Our Reference: 4528-G-L004

**RE: EA Letter Ref. SO/2020/119974/01-L01
Discharge of Condition 16 –110179/FO/2015/S1 for Site at Royce Road, Manchester**

Our ref: SO/2020/119974/01-L01
Your ref: CDN/19/0662
Date: 13 February 2020

DISCHARGE OF CONDITION NUMBERS 8 (LANDSCAPING), 16 (CONTAMINATED LAND), 18 (EXTERNAL PLANT EQUIPMENT), 19 (ACOUSTIC INSULATION), 21 (HIGHWAY DETAILS) AND 24 (CYCLE STORAGE FROM PLANNING APPROVAL REFERENCE 110179/FO/2015/S1.

Ordnance Survey® Historical Mapping Extract

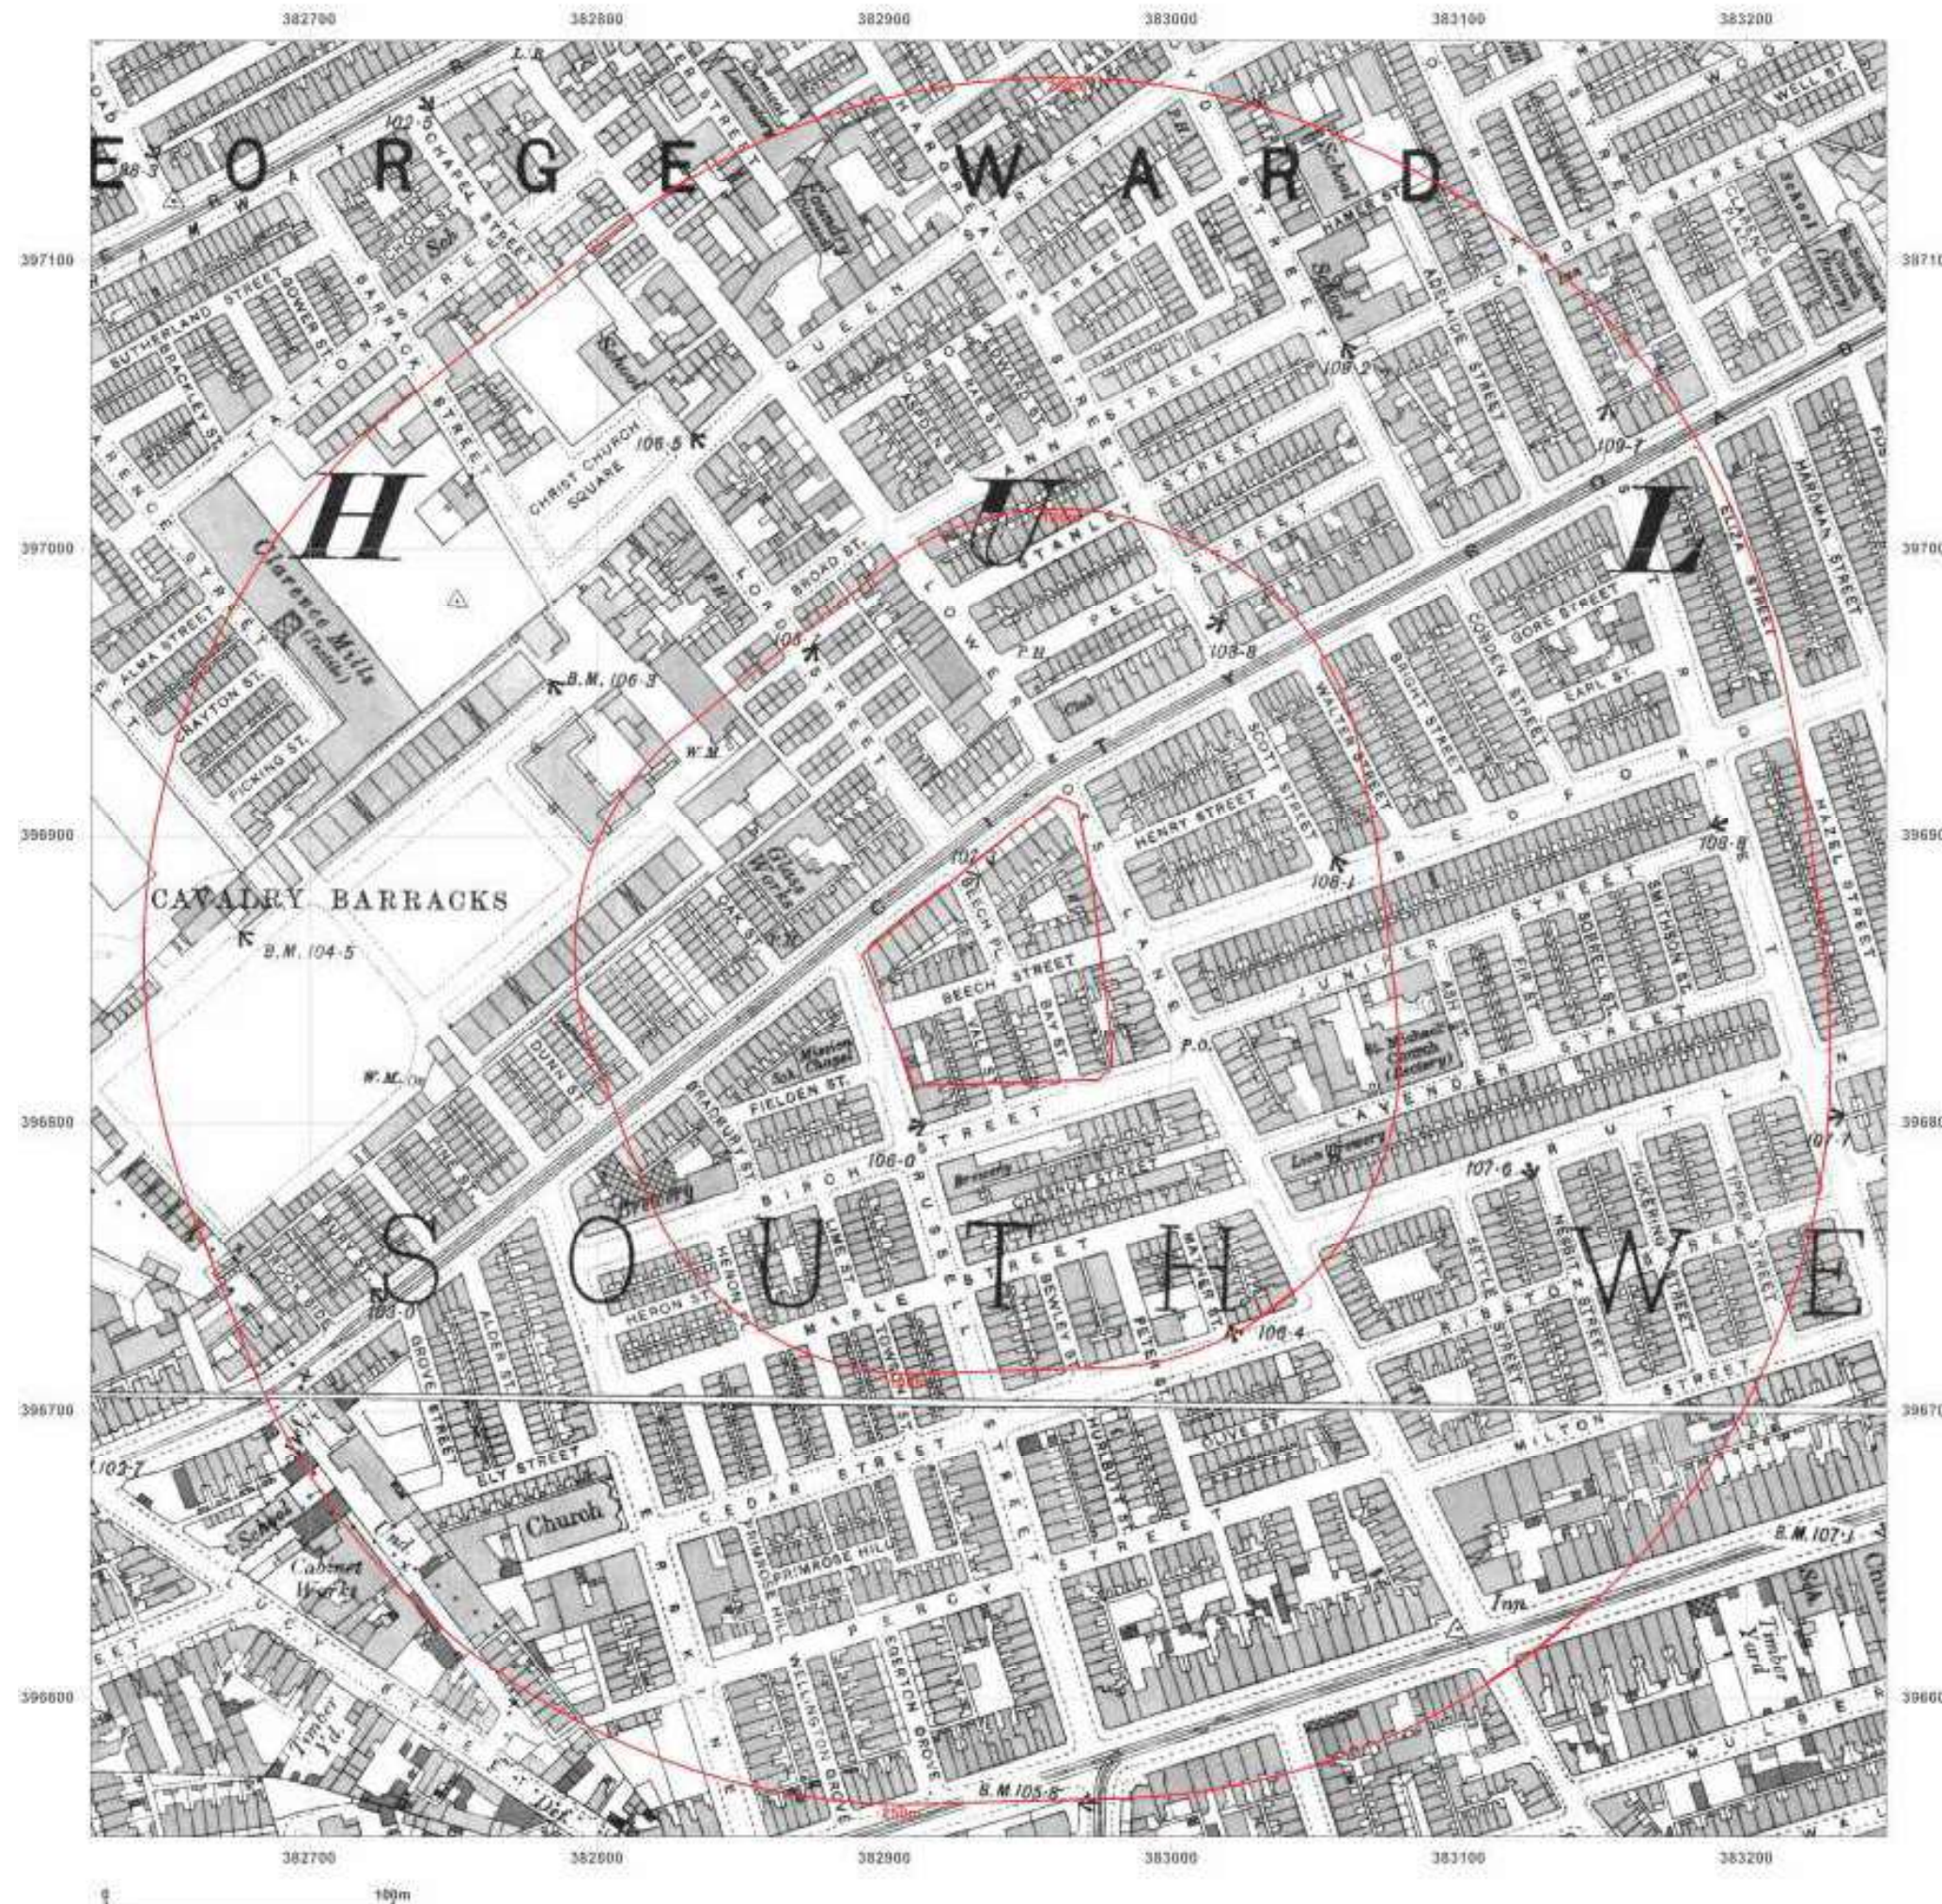
The pump features were identified by Subsurface at desk study stage, as noted in Section 2.1, Table 3 of their 2015 report. An extracted copy of the OS maps from 1851 and 1893 is presented in Appendix B for completeness which shows the 3 No. 'pumps' depicted in a residential setting.

IDG have reviewed the historic OS plans along with the desk study report, and confirm the findings presented in the desk study report to be accurate. The available information confirms the site historical use to be wholly residential, with terraced houses being depicted as present from the earliest OS map (1851) through to 1956, with evidence of a phased demolition of the terraced properties between 1932 and 1962, likely to be the result of damage sustained during WWII. The 1969 map then depicts the site to be occupied by 'Oaklands' residential home for the aged, present through to subsequent demolition between 2010 and 2014.

The 'pumps' indicated on the 1951 OS plans are determined to be small-scale local abstractions associated with providing water supply to the surrounding residential properties, and do not appear to relate to any unidentified industrial use or processes.
